CERTIFICATE OF APPROPRIATENESS

ITEM A10
HPO File #: HP2026_0282

229 W 16th Street
Houston Heights West

Proposal: New Construction – Garage

ATTACHMENT A

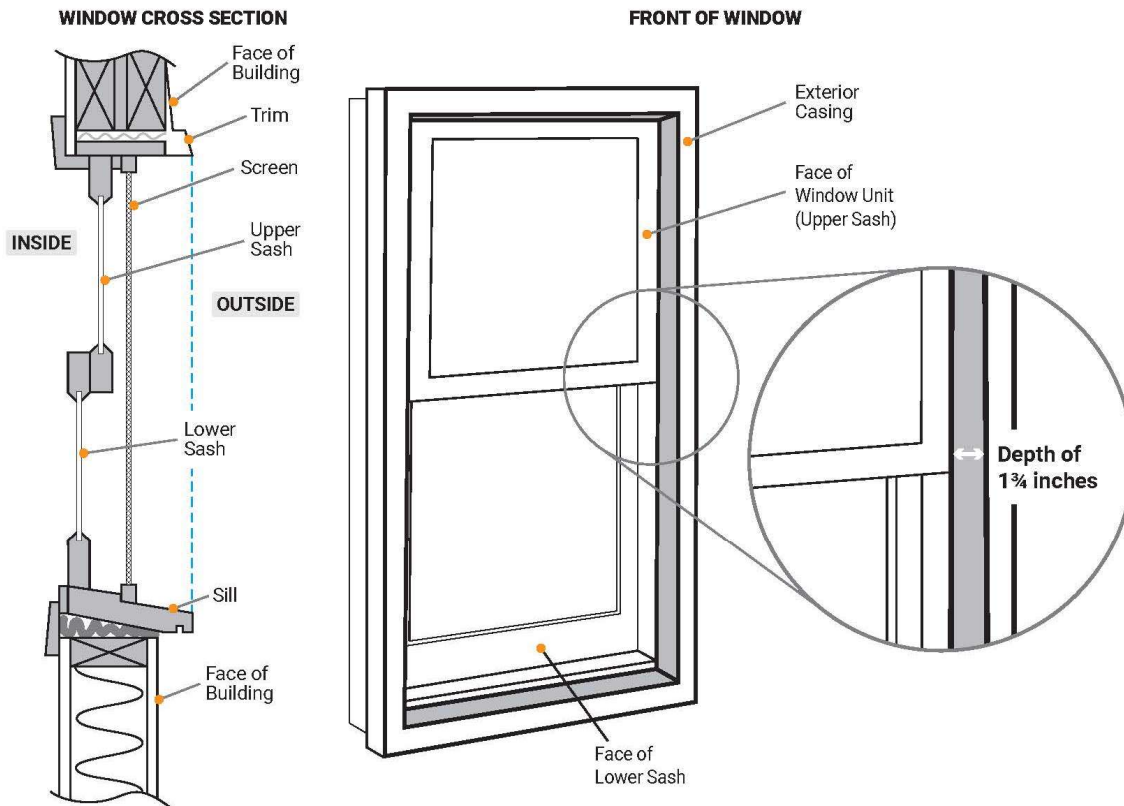
- Garage will be alley-loading with vehicular entry to the rear
- Garage will be separated from a proposed two-story addition by 5' 6"
- Garage will feature an eave height of
- Garage will feature horizontal lap cementitious siding with a 2 and ½ inch reveal.
- Proposed addition on primary residence being considered in a separate COA application (HP2026-0282).
- All new windows need to be inset and recessed. See Attachment A for details.

Minimum 1 3/4 inch Inset

- Depth from Exterior Casing to the Face of the Window Unit (Upper Sash)
- Windows must be 1-over-1 (equally horizontally divided)
- 1 3/4 inch minimum inset for Fixed Window
